828-003-14

ADDENDUM NO. 2

**Centenary United Methodist Church
Fire Sprinkler / Fire Alarm Life Safety Improvements**

Centenary United Methodist Church
Fire & Life Safety Improvements
Beatrice, Nebraska
TCEP No.: 828-003-14

M3.01

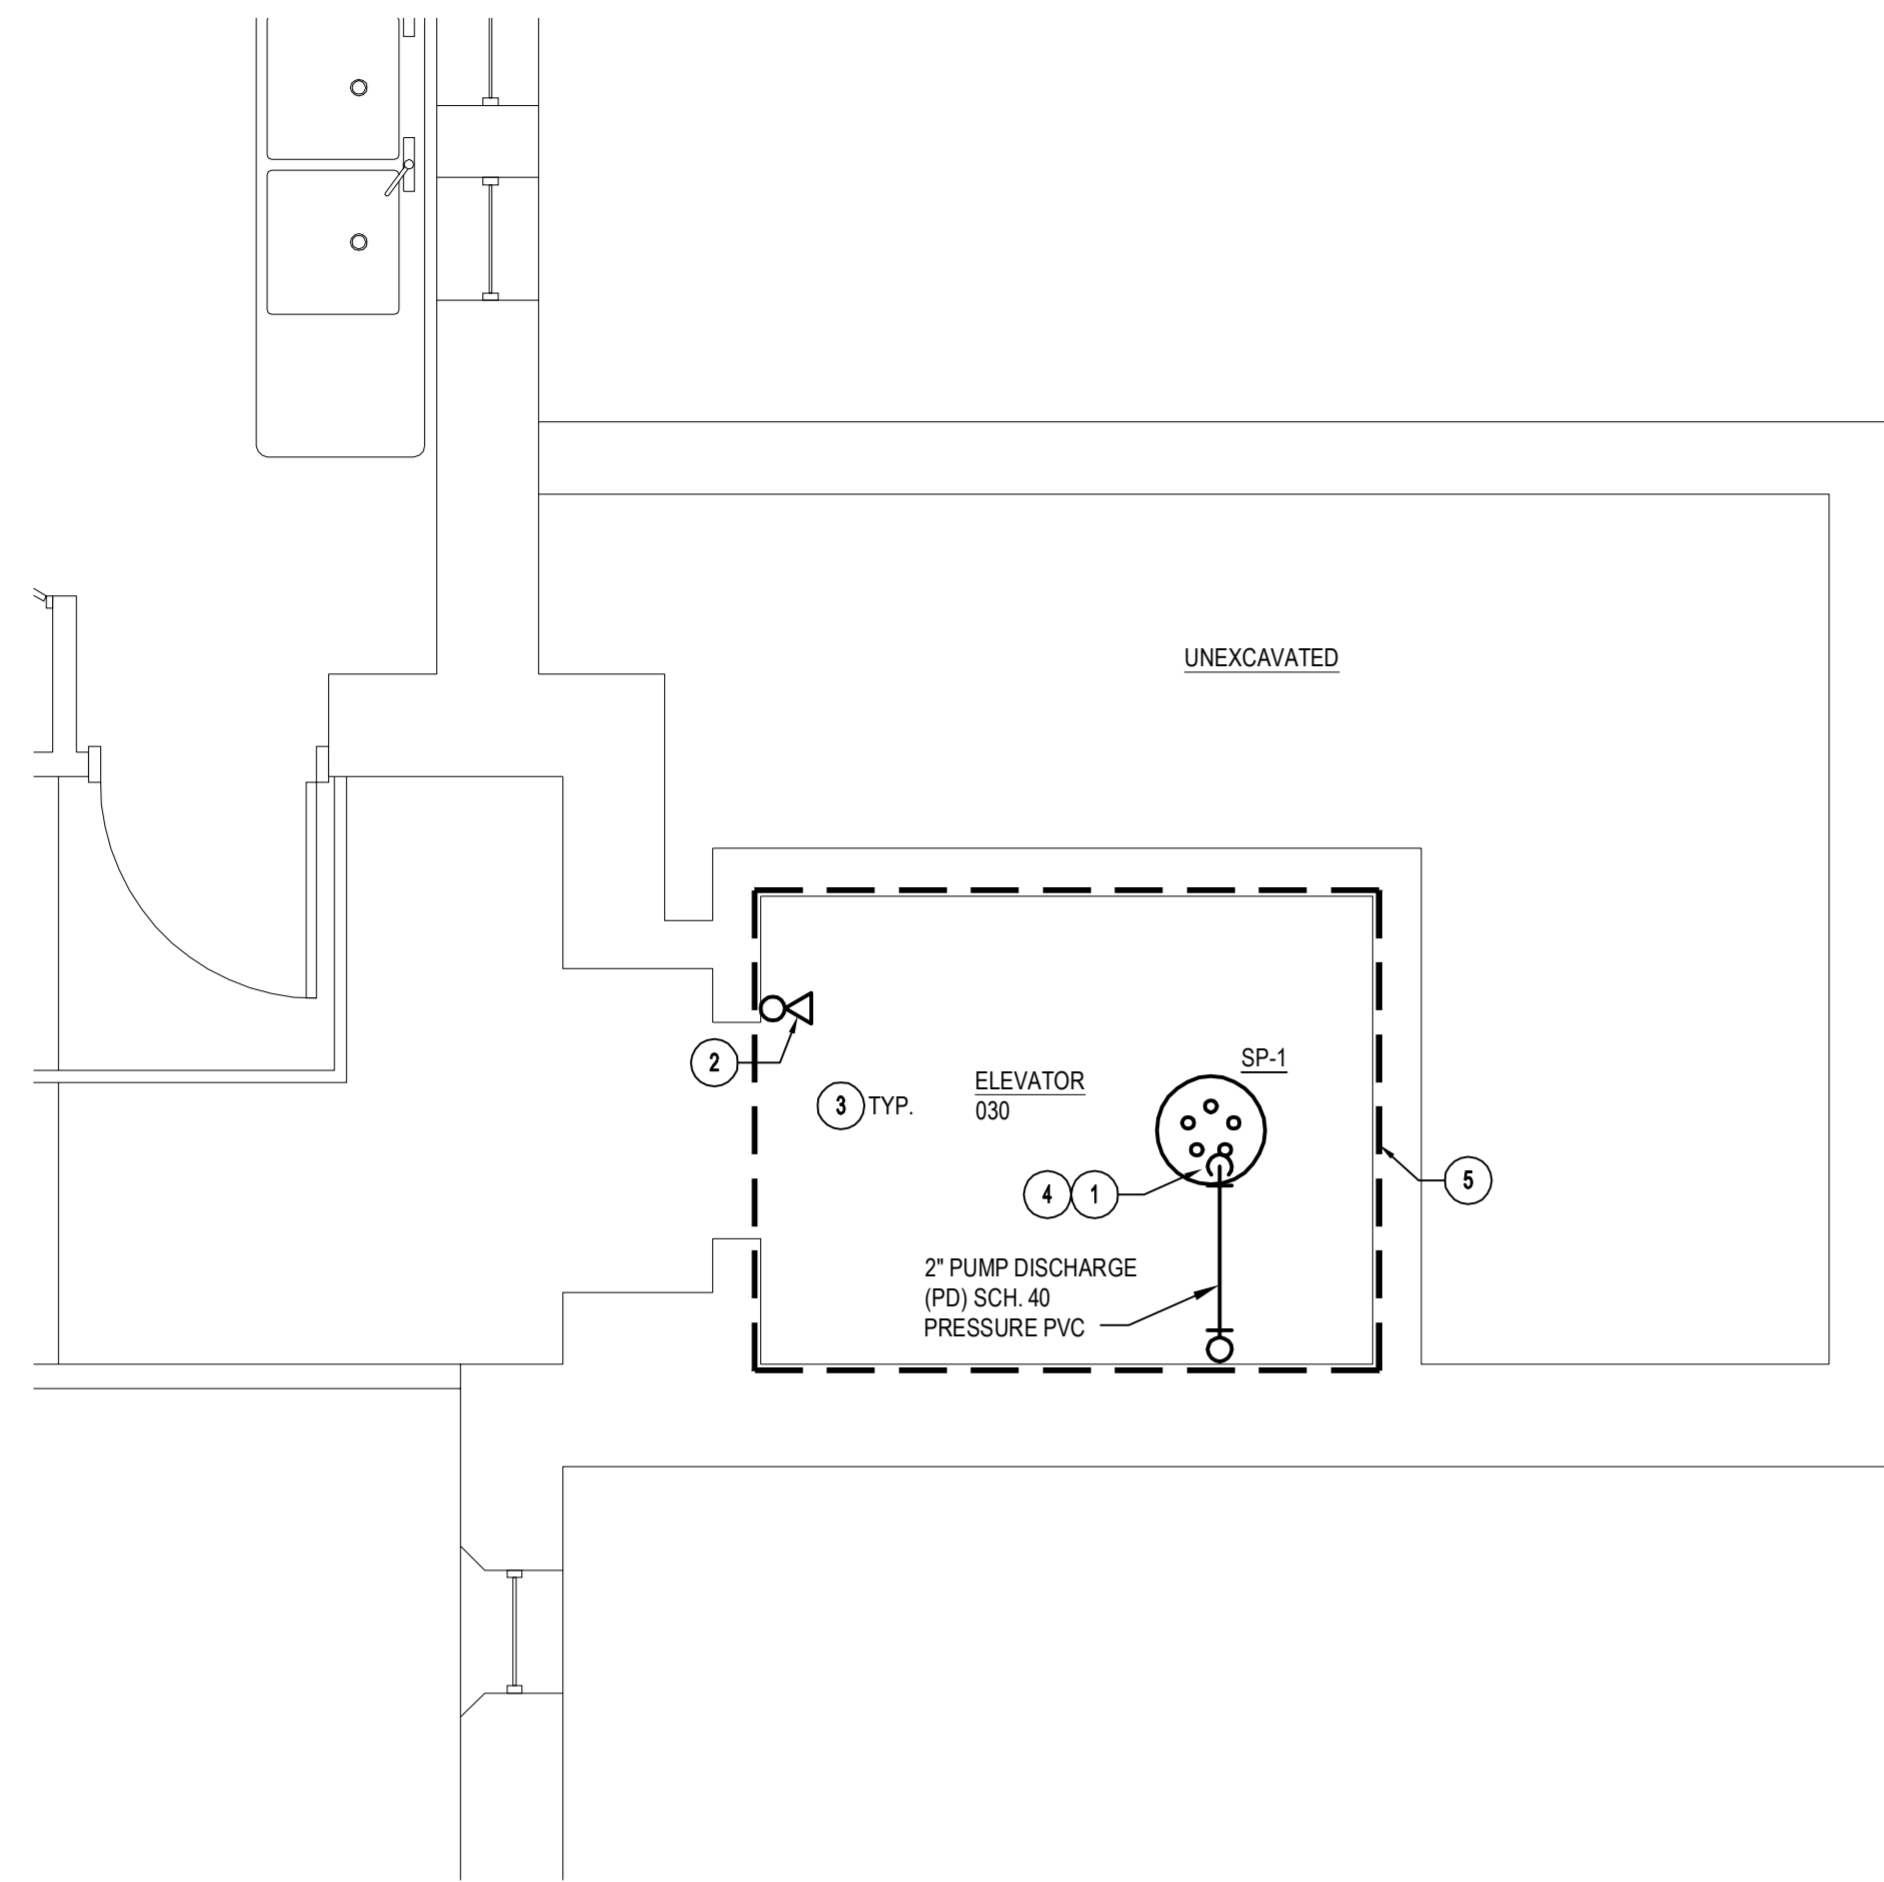
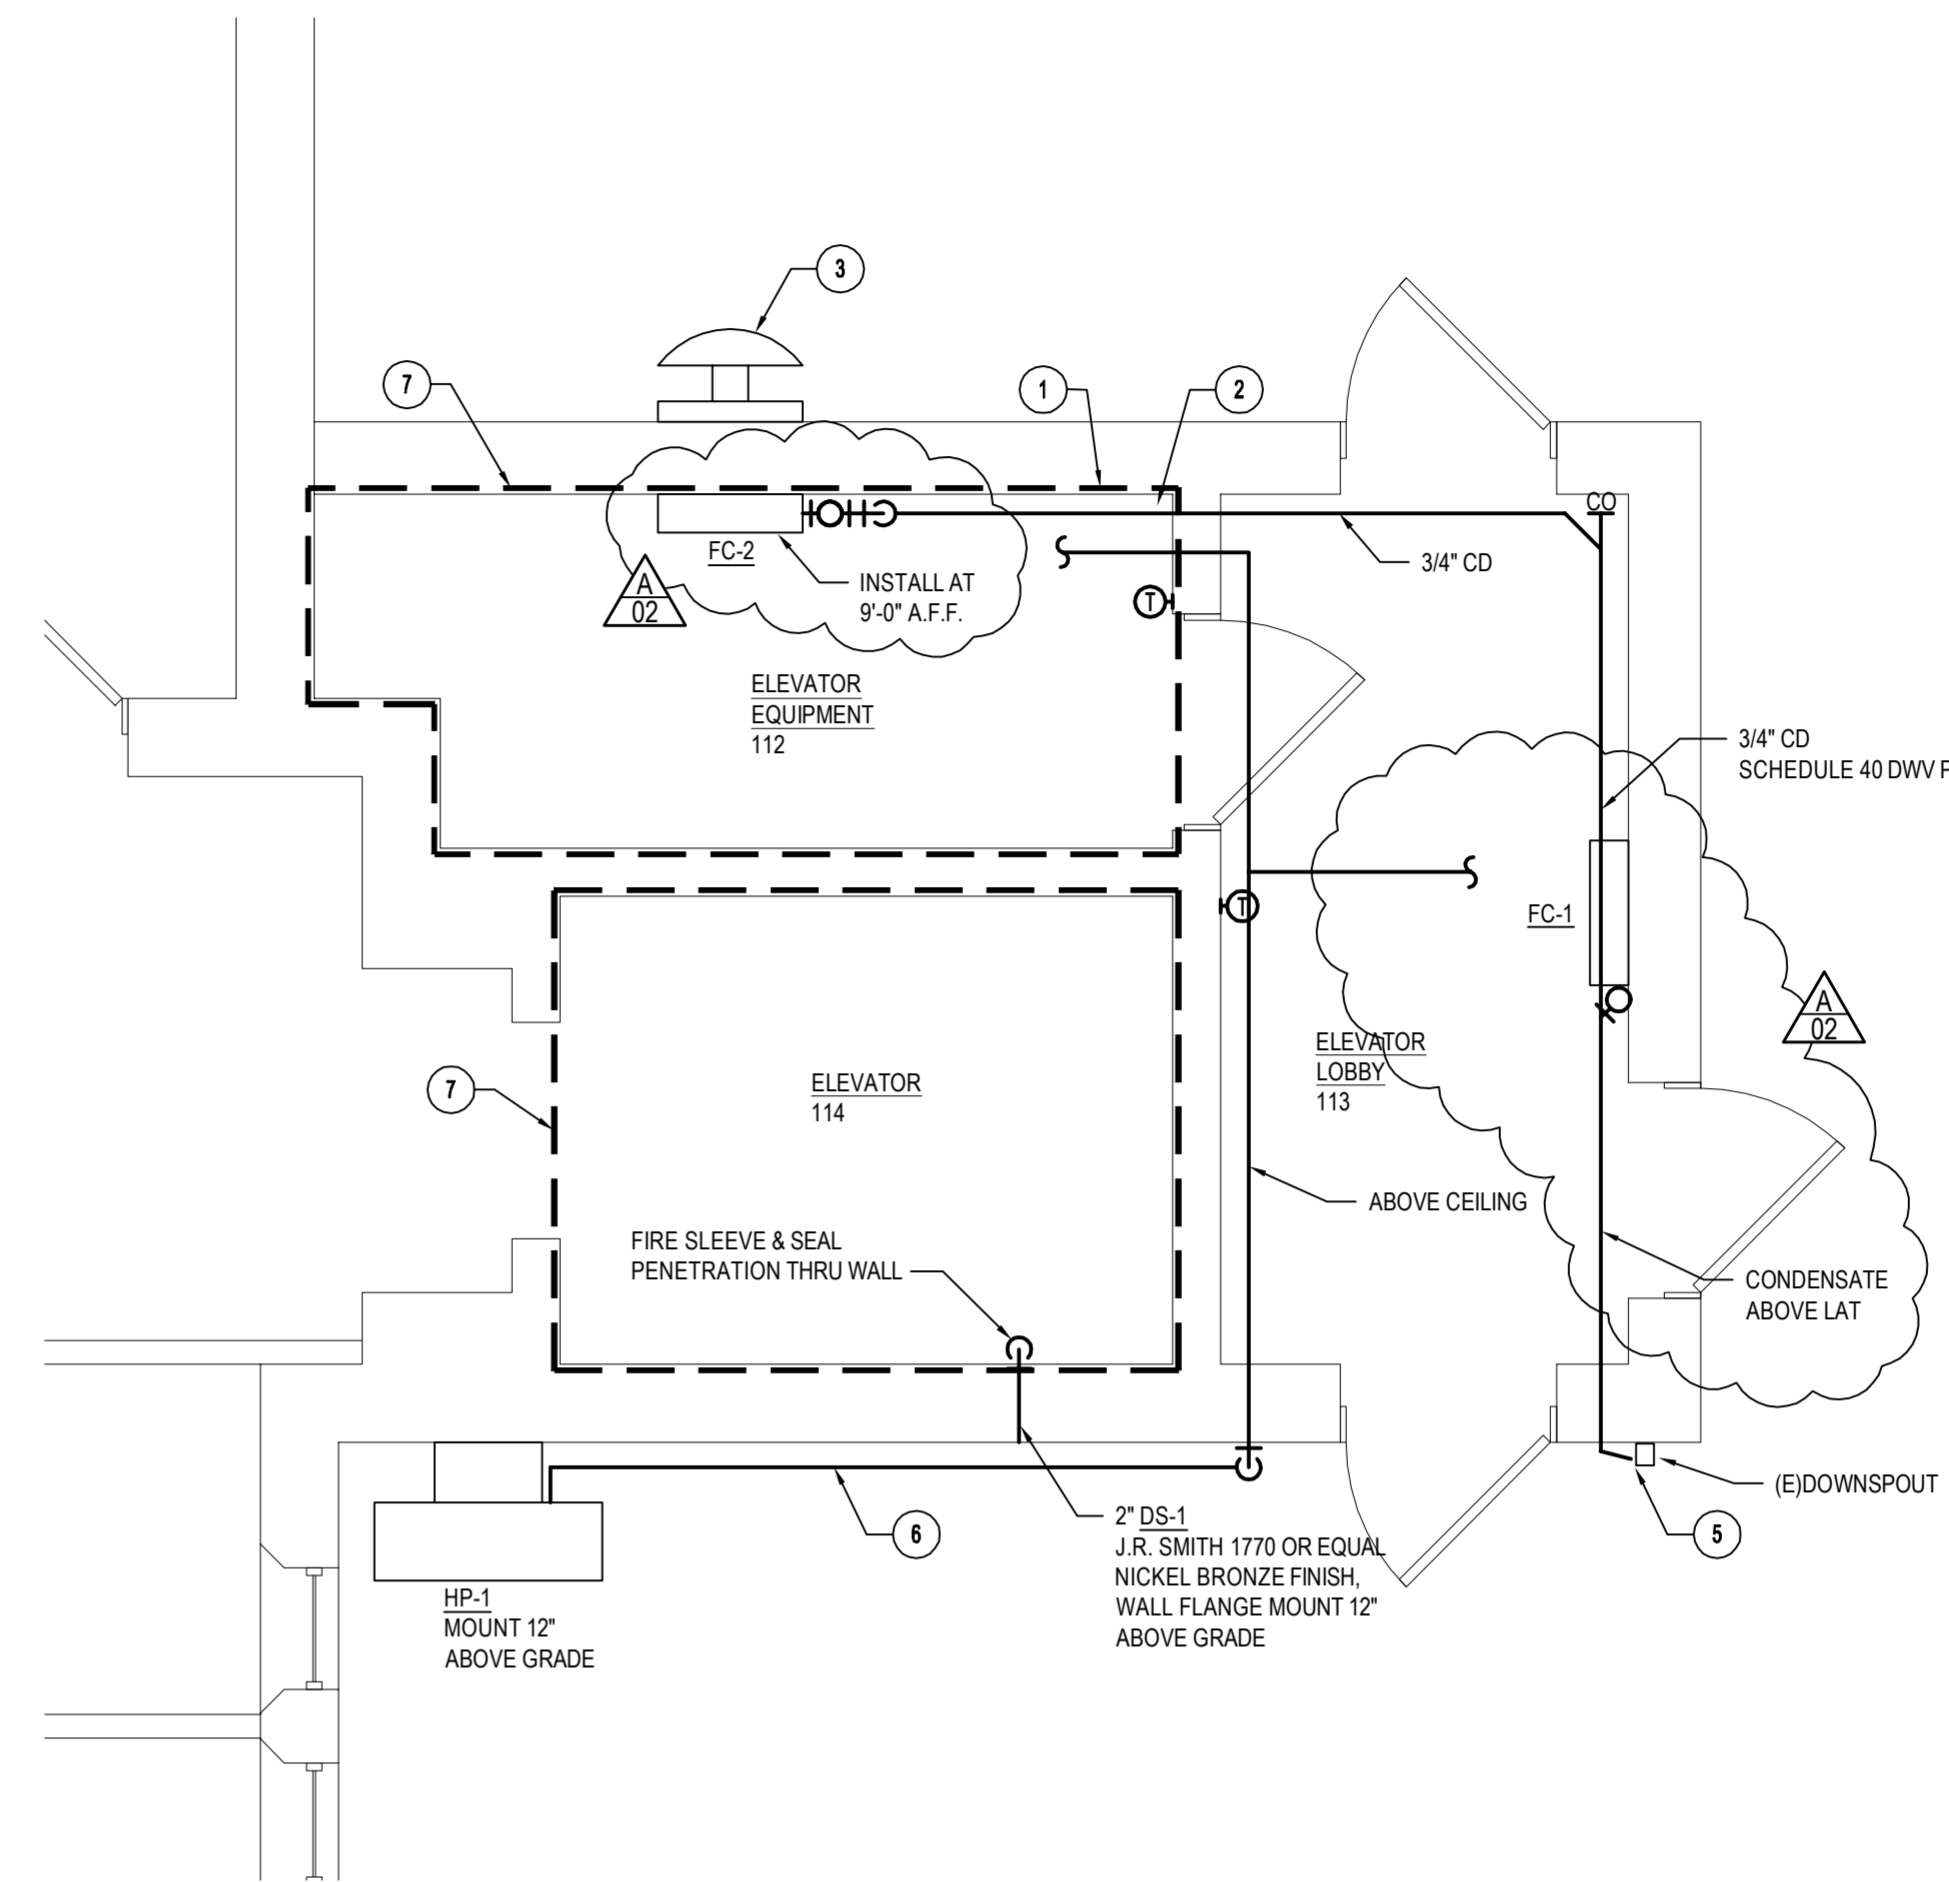
Item 2-14: Sheet M3.01 – Elevator Optimization Plans

M1.4 has been re-issued in its entirety to include changes to the fan coils, see revised schedule for changes.
